IEEE P802.15
Wireless Personal Area Networks

Project	IEEE P802.15 Working Group for Wireless Personal Area Networks (WPANs)	
Title	TG3 LB19 comment resolution	
Date Submitted	[1 October, 2002]	
Source	[James P. K. Gilb] [Apparent Technologies] [9921 Carmel Mountain Rd. #247, San Diego, CA 92129]	Voice: [858-538-3903] Fax: [858-538-3903] E-mail: [gilb@ieee.org]
Re:	[]	
Abstract	[This document is a record of comment resolutions for LB19.]	
Purpose	[To provide a record of the comment resolution for LB19.]	
Notice	This document has been prepared to assist the IEEE P802.15. It is offered as a basis for discussion and is not binding on the contributing individual(s) or organization(s). The material in this document is subject to change in form and content after further study. The contributor(s) reserve(s) the right to add, amend or withdraw material contained herein.	
Release	The contributor acknowledges and accepts that this contribution becomes the property of IEEE and may be made publicly available by P802.15.

Figure 5—PNC handover MSC

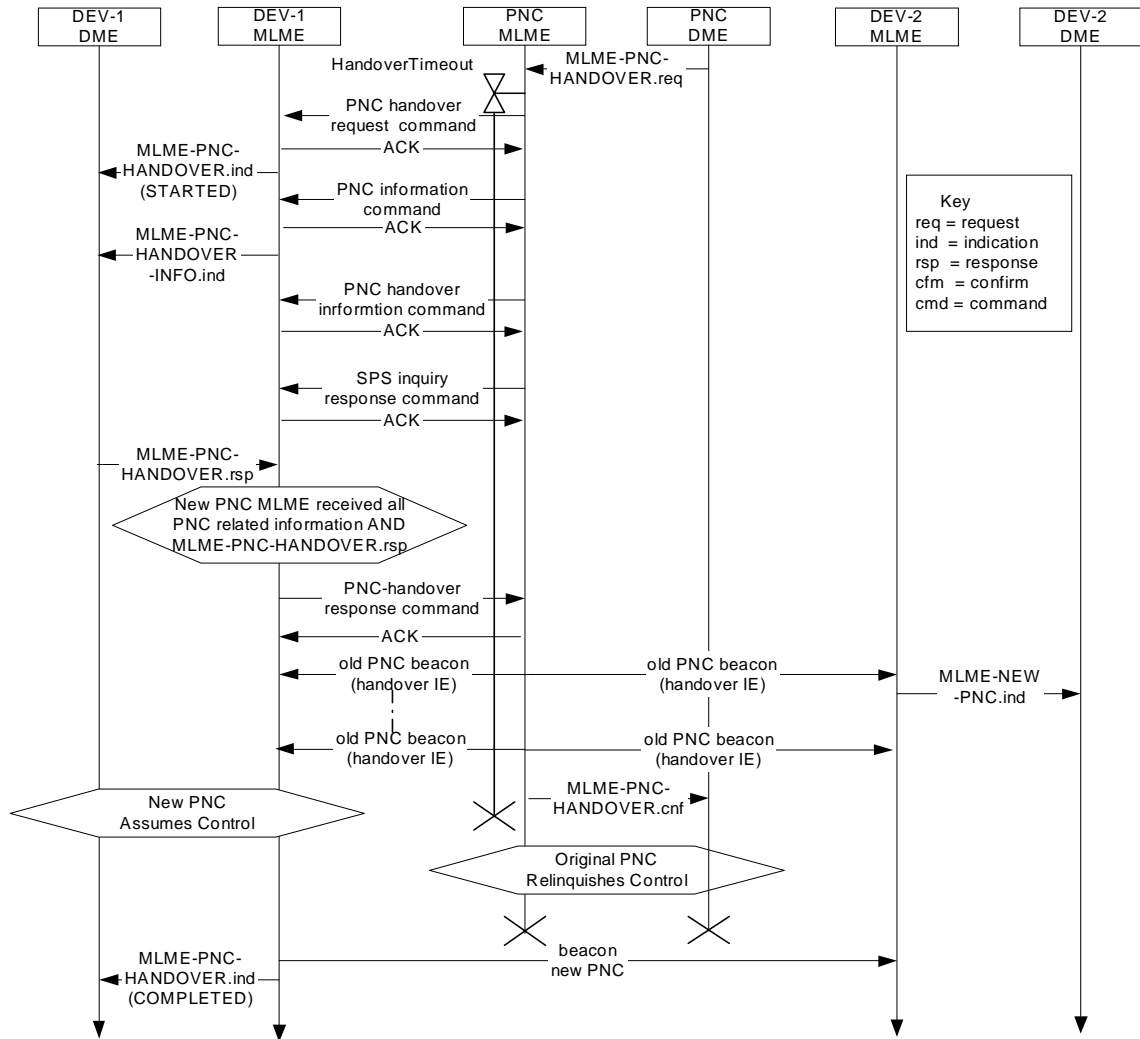
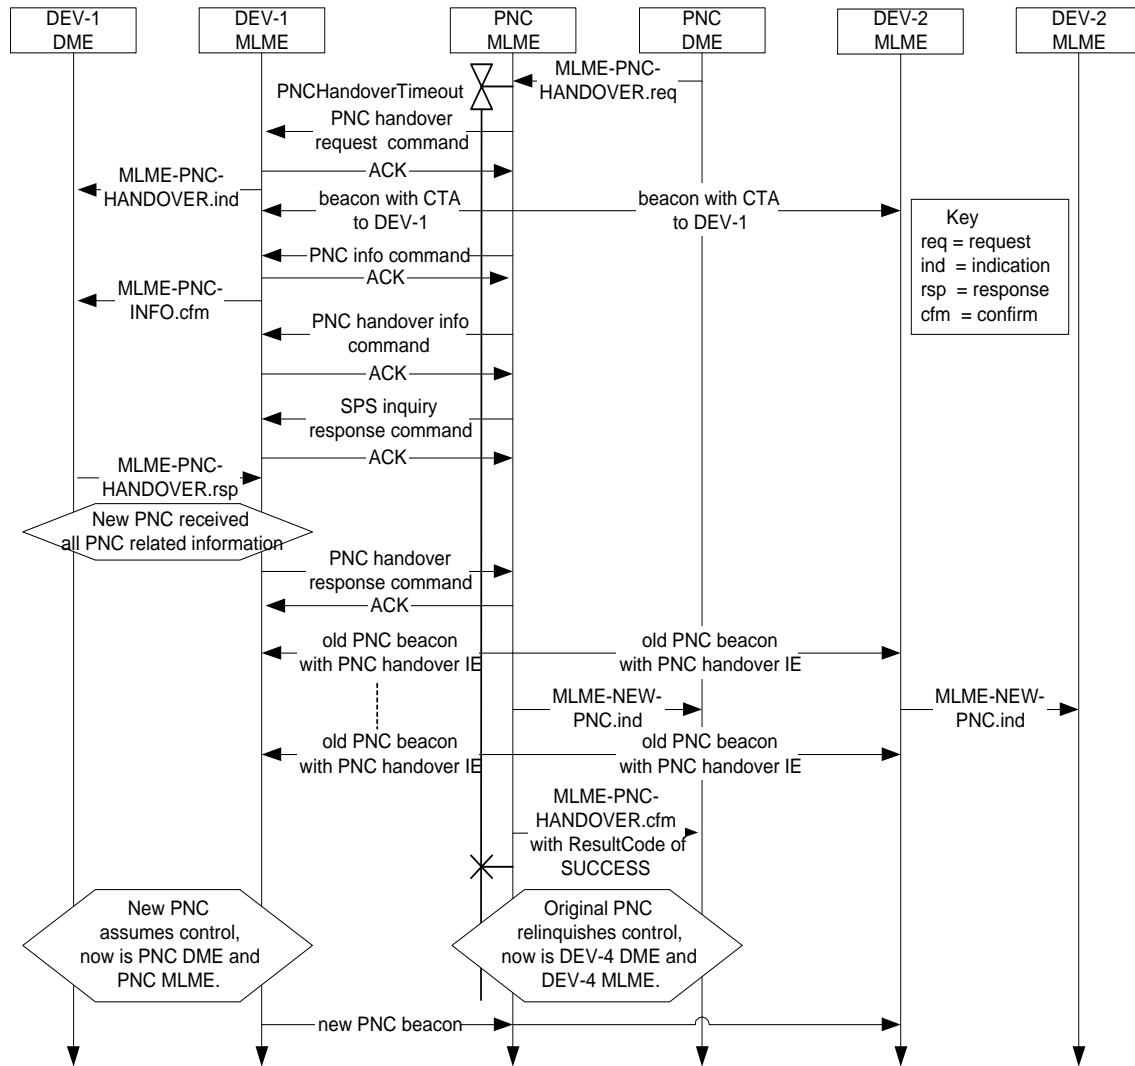
269 (Heberling, TR) - [PNCHndOvr] Some errors in text remain or were introduced after LB17.MSC in Figure 91 is also wrong./KO Text changes for 8.2.3 and ne MSC for Figure 91 are all collected in:02276r7P802-15_TG3-commentsD11_KO.doc, Resolution [03]. **Suggest accept in principle**, “The MSC will be modified as indicated in the resolutions of CID 58 and 232. Make the following text changes: In 6.3.13.4, page 59, line 45, change ‘This primitive informs the originating DME its request for information from the PNC is complete.’ to be ‘This primitive informs the DME that the MLME has received a PNC information command, {xref 7.5.4.2}.’ In 7.5.3.1, page 138, line 20 ‘the number of information records to be transferred using the PNC information command frame(s).’ to be ‘the number of DEV information records, {xref PNC handover info command}, that will be transfered from the old PNC to the new PNC.’ In 8.2.3 PNC Handover, delete page 156, line 8-9, redundant, same text in paragraph below. Add to page 156, line 19, ‘The PNC handover information command shall not be sent if the PNC has indicated in the PNC handover request command that it does not have any CTRBs to transfer.

1 Handover MSC - various comments, suggestion from 02276r7P802-15_TG3-commentsD11_KO.doc below
2 (with some editorial work):

463 (Gubbi, TR) - Figure-91 is a well done job, but the text needs to supplement some info that can not be expressed in the figure, which is incomplete in the current update to this para. It should be mentioned that these commands shall be sent by PNC even if there is no information present that fits into those commands so that the rx-DEV knows the exact end of the transaction. For example, what if there are no DEVs in power save mode. Still the SPS-inquiry-response-command shall be sent by PNC. It should be mentioned that the three commands in Figure-91 (PNC-info-command, PNC-handover-info-command and SPS-inquiry-response-cmd) shall be sent by PNC even if there is no information present that fits into those commands so that the rx-DEV knows the exact end of the transaction. For example, what if there are no DEVs in power save mode. Still the SPS-inquiry-response-command shall be sent by PNC. **Suggest accept in principle,** "Rather than send the empty commands, the PNC handover request will contain the number of CTRBs and SPS sets that will be transferred. If the number of items is zero, then the old PNC shall not send the command and the new PNC will not expect to receive it. It is not possible for the number of DEVs to be less than 2 (i.e. the old PNC and the new PNC), so the PNC information command will always be sent. This is documented in the resolution of CID 269."

The SPS inquiry response command shall not be sent if the PNC has indicated in the PNC handover request command that it doesn’t have any SPS sets to transfer.’

Add to page 156, line 35, ‘The new PNC shall broadcast its first beacon at the time the beacon would have been sent by the old PNC. This time may vary from the actual time due to clock inaccuracies of old and new PNCs. The new PNC shall start sending beacons with the beacon number counter set to one more than the beacon number of the last beacon that will be sent by the old PNC.’

Add page 156, line 40ff, ‘The PNC shall ensure that the beacon countdown includes at least one system wake beacon and at least aMaxLostBeacons beacons following that system wake beacon. The only exception to this requirement is if the PNC will be shutting down and does not have enough time to to wait for the next system wake beacon to complete the handover process. {Ed. note: This line may be moved to a new 8.1.1 that describes all beacon announcements.’}
